R20TS0239EJ0101

RX600 and RX200 Series

I²C Bus Single Master Control Software Using RIIC Serial Interface

Outline

Figure 1 Last Data Reception Waveform in Successful and Error Cases

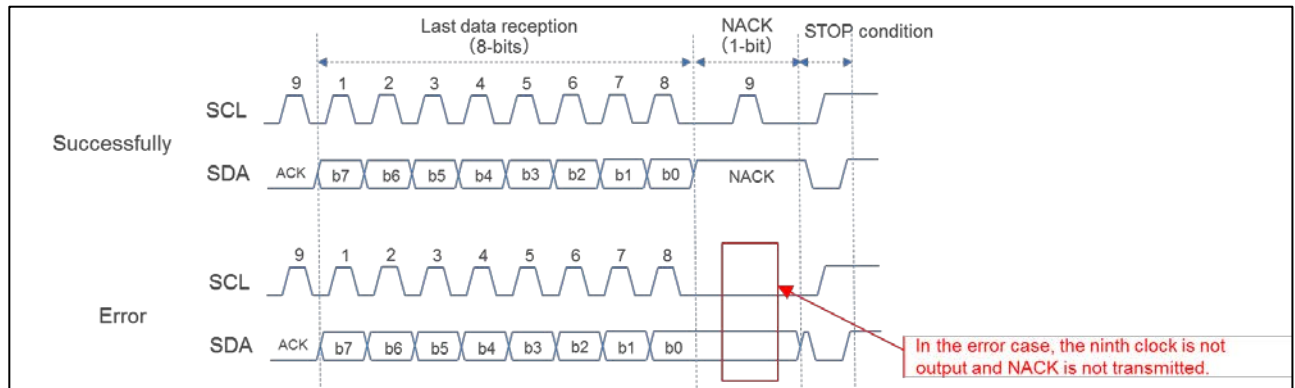
In successful reception of the last data, the MCU receives 8-bit data, and then transmits 1-bit NACK. However, in the error case, NACK is not transmitted even after reception of the last data.

- (1) The software control protocol is set to master reception or master composite.
- (2) System clock (ICLK) > peripheral module clock (PCLK) > SCL clock is established^(Note).

Note: (Reference values) The problem occurs when ICLK = 100 MHz, PCLK = 50 MHz, SCL clock =< 100 KHz.

Change the source code for the following function as shown in red.

r_iic_drv_receive_end_setting() function of r_iic_drv_sfr_rxXXX.c^(Note)

/* Sets ICMR3.ACKBT bit. */
    *pcICMR3 |= R_IIC_ICMR3_ACKWP_SET;
    *pcICMR3 |= R_IIC_ICMR3_ACKBT_SET;
    *pcICMR3 &= R_IIC_ICMR3_ACKWP_CLR;

Figure 2 Communication Waveform When Using a Channel Other Than Channel 0 of the RIIC in Successful and Error Cases

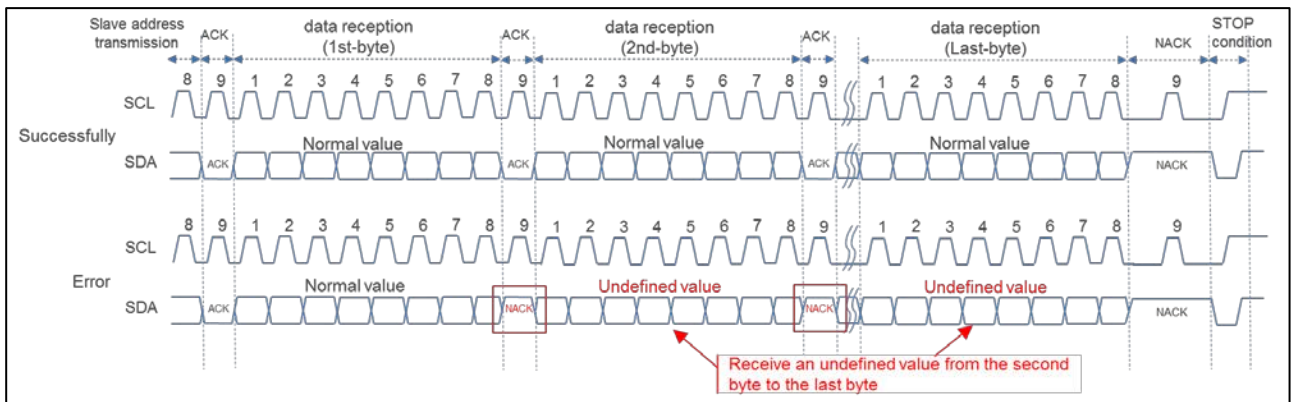
In successful reception of data, the MCU receives 8-bit data, and then transmits 1-bit ACK (for the last data, NACK). In the error case, NACK is always transmitted after reception of data. Therefore, an undefined value is received from the slave device during the period from reception of the second byte of data to reception of the last data^(Note).

- (1) The software control protocol is set to master reception or master composite.
- (2) A channel other than channel 0 of the RIIC is used.
- (3) An interrupt other than the RIIC occurs in the period from when the ICDRR register is read to when the ICMR3.ACKBT bit is set to "1" in the last data reception processing.
- (4) A stop condition has been issued during the interrupt processing of (3).
- (5) Data reception is re-executed after the issue of a stop condition of (4).

Change the source code for the following function as shown in red.

r_iic_drv_next_comm_setting() function of r_iic_drv_sfr_rxXXX.c^(Note)

/* Checks the internal mode. */
    if ((R_IIC_MODE_READ == g_iic_InternalInfo[pRIic_Info->ChNo].Mode) ||
        (R_IIC_MODE_COMBINED == g_iic_InternalInfo[pRIic_Info->ChNo].Mode))
    {
        /* Clears ICMR3.RDRFS bit.*/
        /* Clears ICMR3.ACKBT bit. */
        *pcICMR3 |= R_IIC_ICMR3_ACKWP_SET;
        *pcICMR3 = R_IIC_ICMR3_INIT;
    }
